**Addendum No. 1**

Re: **Chester Plaza Retail Center**  
13830-13844 Manchester Road  
Ballwin, Missouri 63011

New Exterior Alterations for:  
**Chester Plaza  
Retail Center**  
13830 - 13844 Manchester Road  
Ballwin, Missouri 63011

SHEET  
**A3**  
WALL SECTIONS

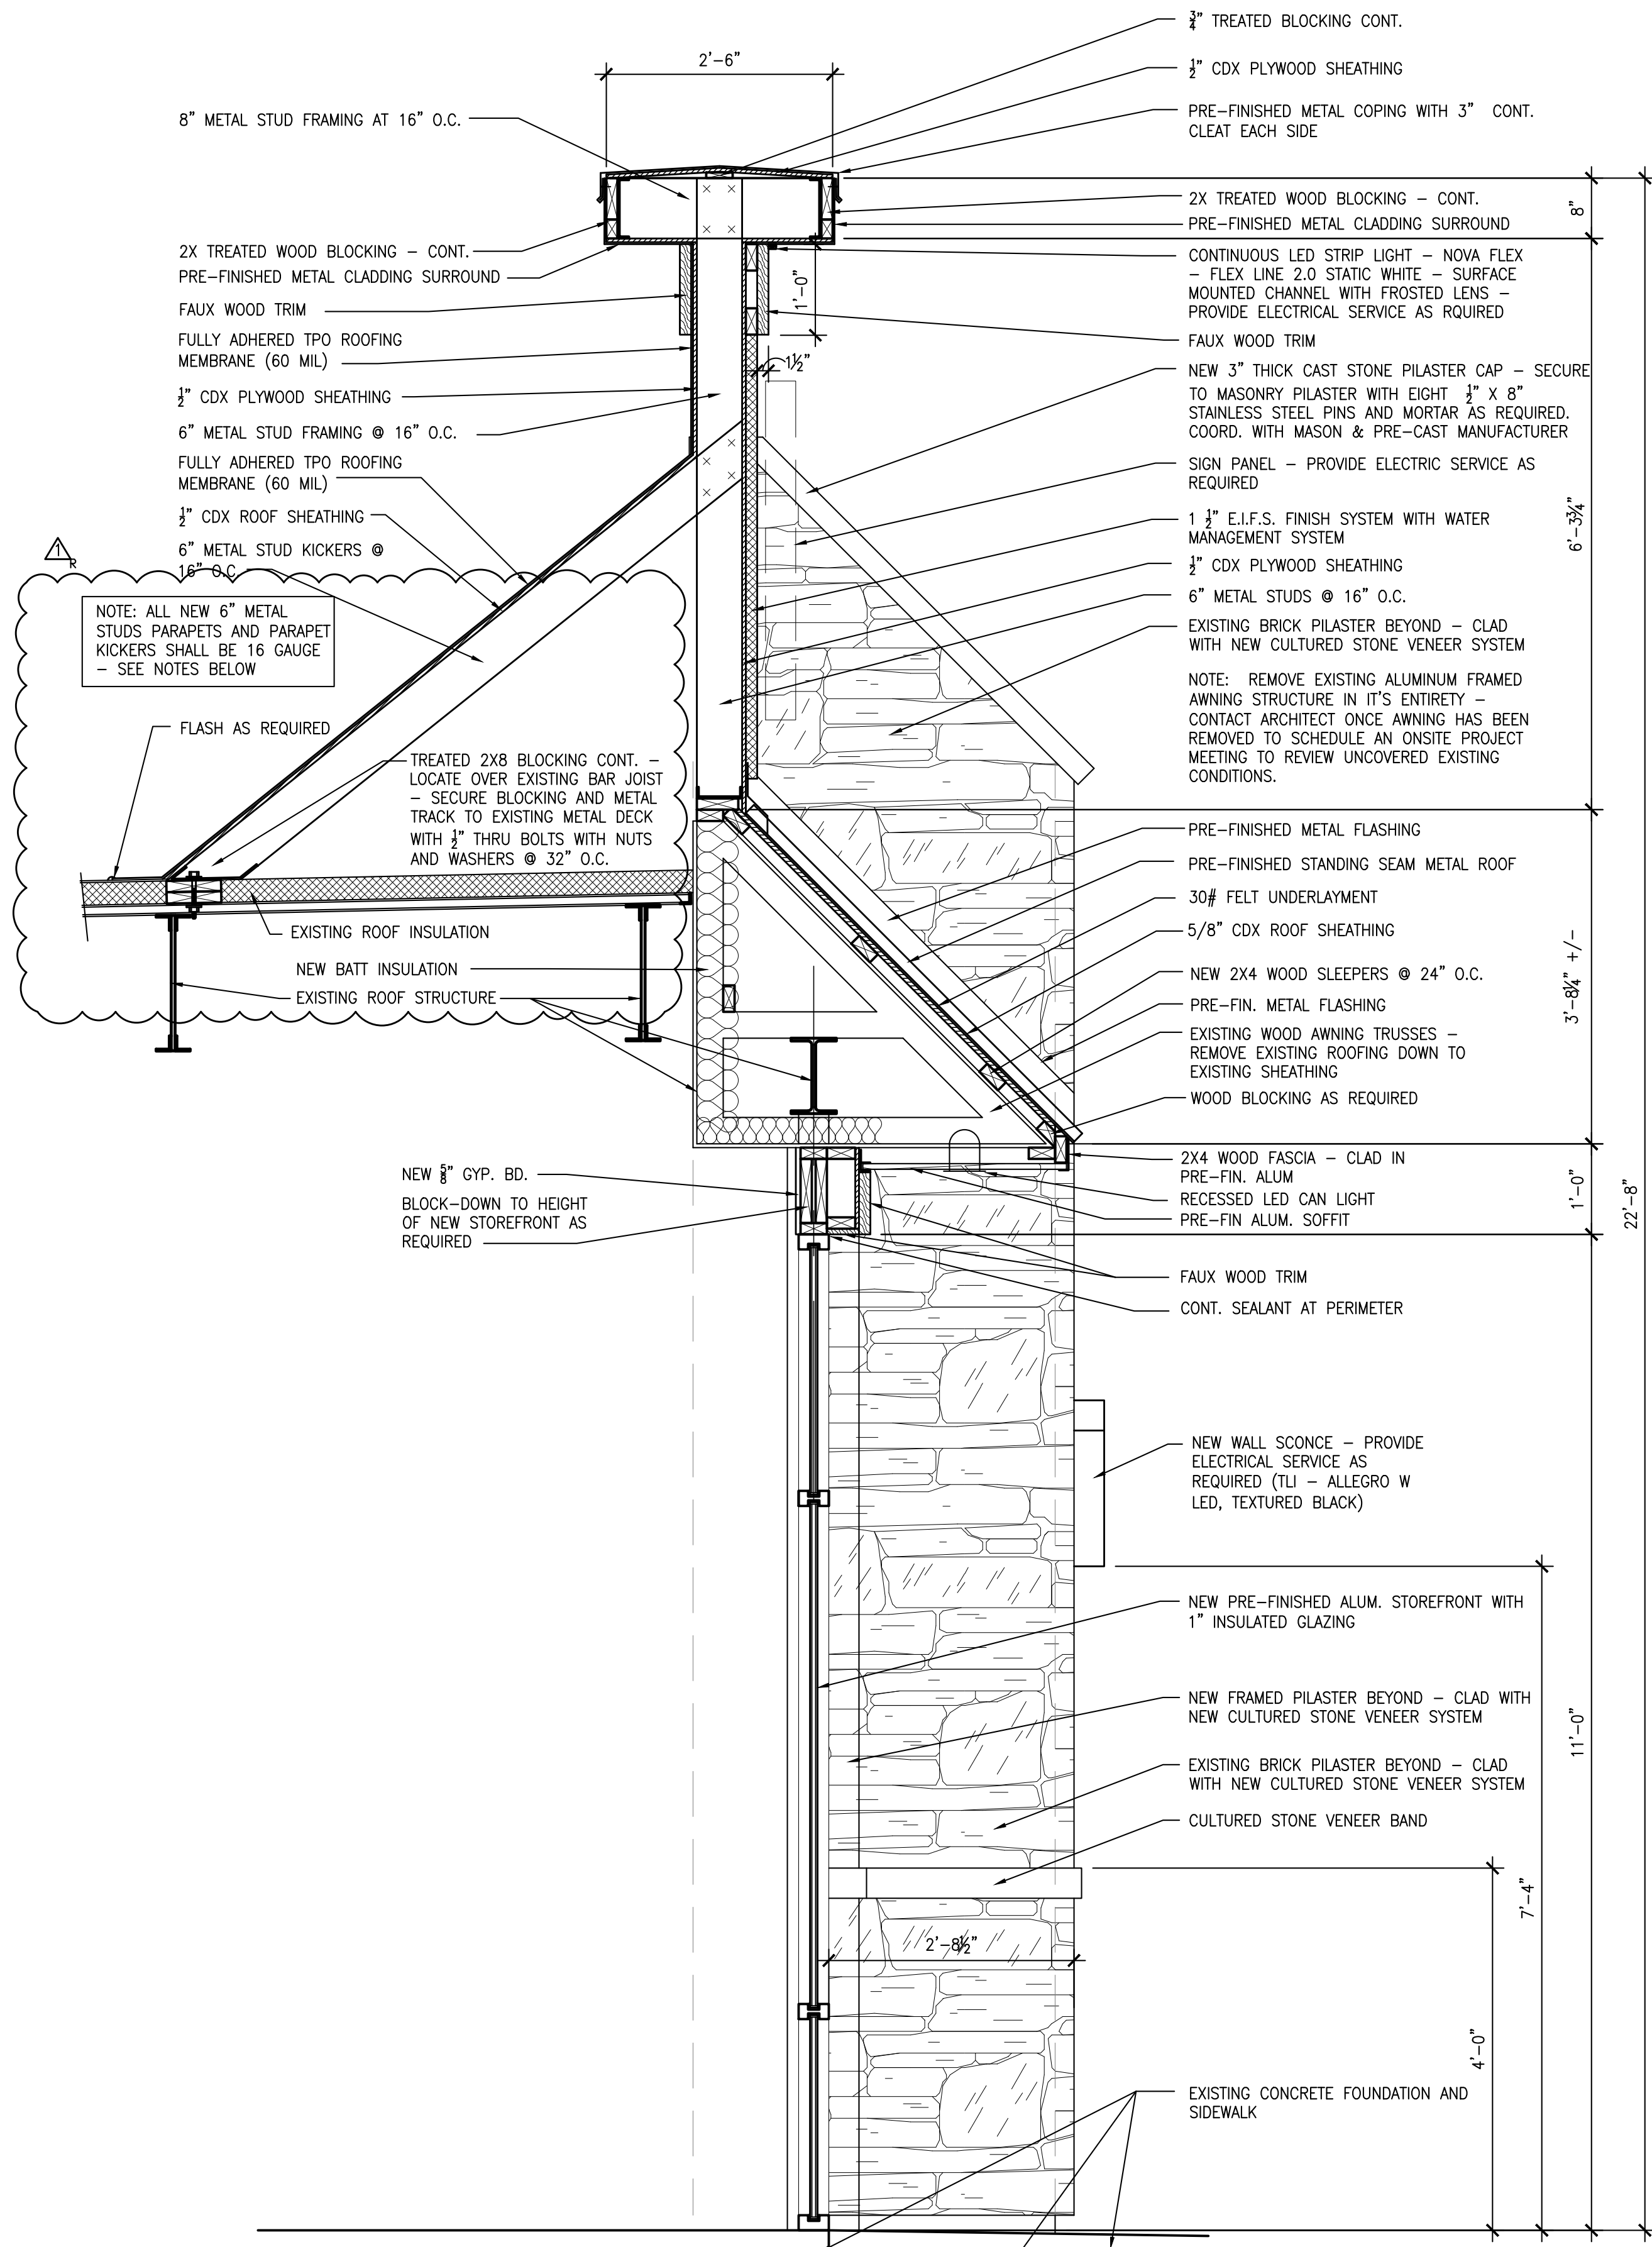
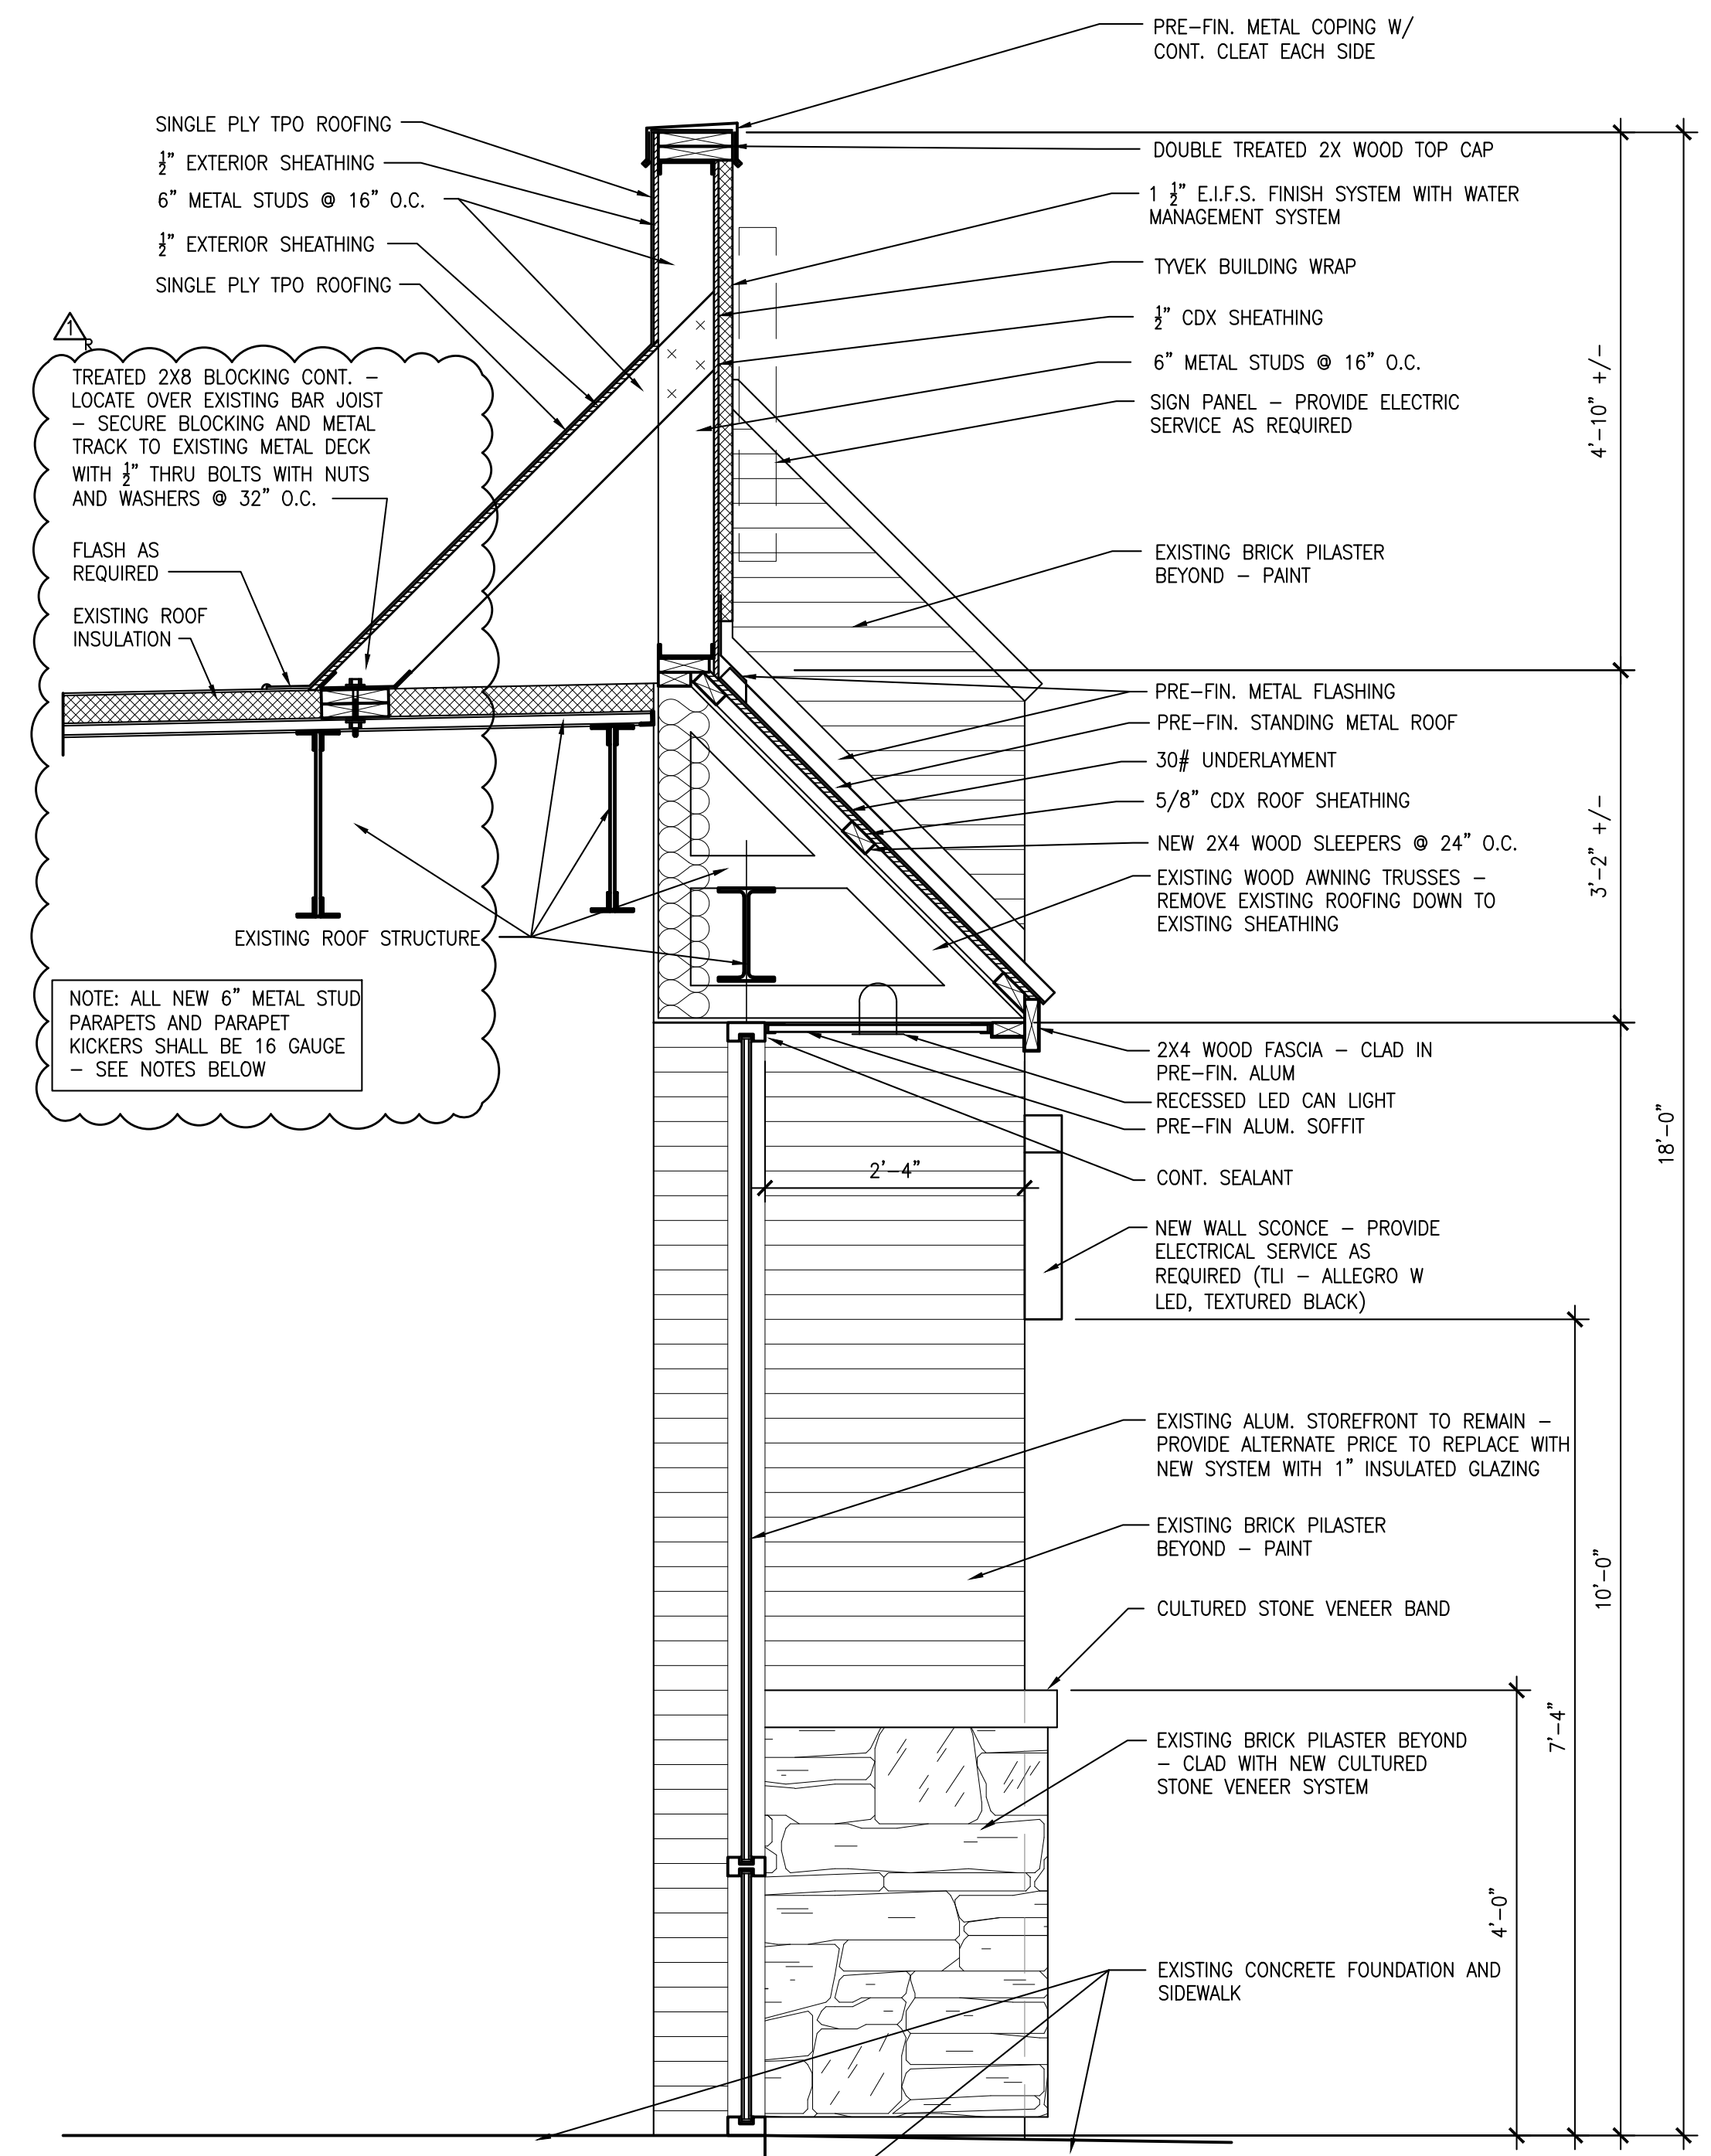
1. Sheet A3 - Wall Sections
  - a. Added wall section notes.
  - b. Clarified attachment of new parapets.

- WALL SECTION NOTES:**
1. WALL SECTION DRAWINGS HAVE BEEN PREPARED BASED UPON FIELD OBSERVATIONS AND WITHOUT THE AID OF EXISTING BUILDING DRAWINGS. CONTRACTOR SHALL INFORM THE ARCHITECT OF ANY DISCREPANCIES DURING THE COURSE OF BIDDING & CONSTRUCTION.
  2. EXISTING CONSTRUCTION TO BE REMOVED AND DISPOSED OF AS REQUIRED TO FACILITATE THE NEW EXTERIOR FACADE DESIGN, INCLUDING BUT NOT LIMITED TO: ALUMINUM FRAMED FABRIC AWNINGS, EXISTING ROOFING & ACCESSORIES AT EXISTING WOOD AWNINGS, EXISTING ALUM. SOFFITS, FLASHING, EXISTING SOFFIT LIGHTING, ETC...
  3. ALL CFS STOCK IS 16-GA X 50-KSI YIELD STEEL X 1.625" FLANGE X 1/2" MIN. RETURN; USE STOCK DEPTH AS SHOWN (6" OR 8", ETC., AS REQ'D).
  4. ALL CDX, OSB, DENSGLASS OR OTHER SHEATHING IS FASTENED TO THE CFS STOCK WITH #8 SIMPSON STRONG-DRIVE PPSD SHEATHING-TO-CFS SCREWS OR EQUIVALENT @ 6" O/C DIRECT EDGES & 12" O/C FIELD.

- WALL SECTION NOTES:**
1. WALL SECTION DRAWINGS HAVE BEEN PREPARED BASED UPON FIELD OBSERVATIONS AND WITHOUT THE AID OF EXISTING BUILDING DRAWINGS. CONTRACTOR SHALL INFORM THE ARCHITECT OF ANY DISCREPANCIES DURING THE COURSE OF BIDDING & CONSTRUCTION.
  2. EXISTING CONSTRUCTION TO BE REMOVED AND DISPOSED OF AS REQUIRED TO FACILITATE THE NEW EXTERIOR FACADE DESIGN, INCLUDING BUT NOT LIMITED TO: ALUMINUM FRAMED FABRIC AWNINGS, EXISTING ROOFING & ACCESSORIES AT EXISTING WOOD AWNINGS, EXISTING ALUM. SOFFITS, FLASHING, EXISTING SOFFIT LIGHTING, ETC...
  3. ALL CFS STOCK IS 16-GA X 50-KSI YIELD STEEL X 1.625" FLANGE X 1/2" MIN. RETURN; USE STOCK DEPTH AS SHOWN (6" OR 8", ETC., AS REQ'D).
  4. ALL CDX, OSB, DENSGLASS OR OTHER SHEATHING IS FASTENED TO THE CFS STOCK WITH #8 SIMPSON STRONG-DRIVE PPSD SHEATHING-TO-CFS SCREWS OR EQUIVALENT @ 6" O/C DIRECT EDGES & 12" O/C FIELD.
